# 2017 ARTC Hunter Valley Access Undertaking

3 February 2017

The 2017 Hunter Valley Access Undertaking (**2017 HVAU**) has been submitted to replace the current 2011 HVAU. The 2017 HVAU replaces the 2016 HVAU which was withdrawn by ARTC prior to the Australian Competition and Consumer Commission (**ACCC**) making a draft determination on whether it would approve the proposed access undertaking.

**Figure 6. Indicative Representation of an Alternate Price Structure**

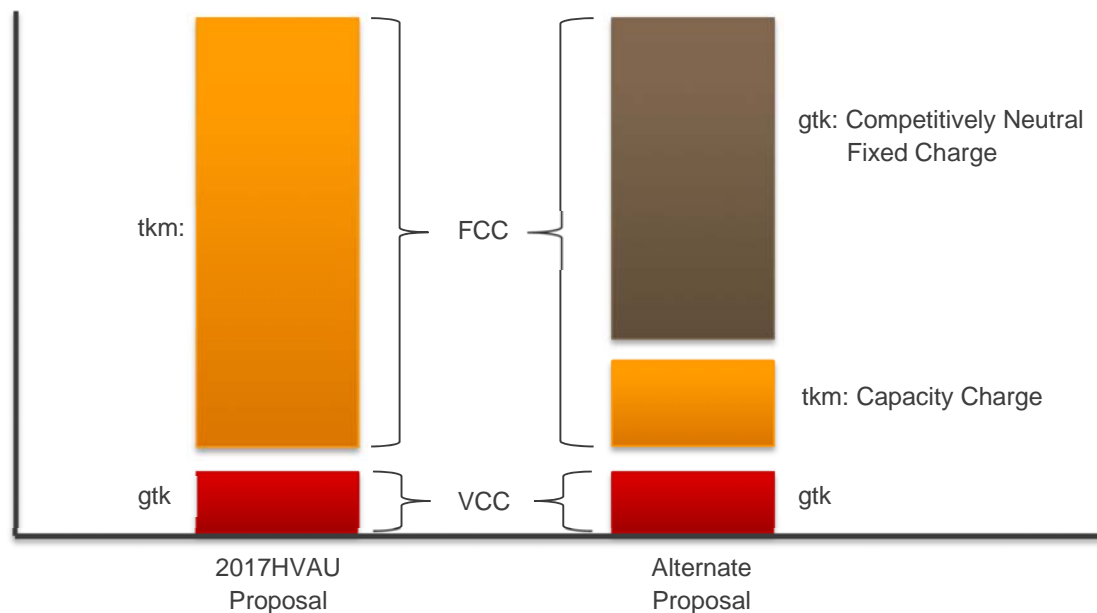
In order to retain the simplicity of only two tariff metrics it is likely to be preferable for the common cost charge to be priced in \$/gtk. A comparison between this indicative proposal and the path-based pricing proposal is illustrated in the following graph.

Unless evidence is presented which empirically establishes the unit cost of the next incremental block of capacity for the relevant pricing zone, the capacity charge should not exceed LRAIC. Given the relative proportion of assets which would be expected to be renewed or replaced over the long term this is not expected to represent a major proportion of the total fixed costs.
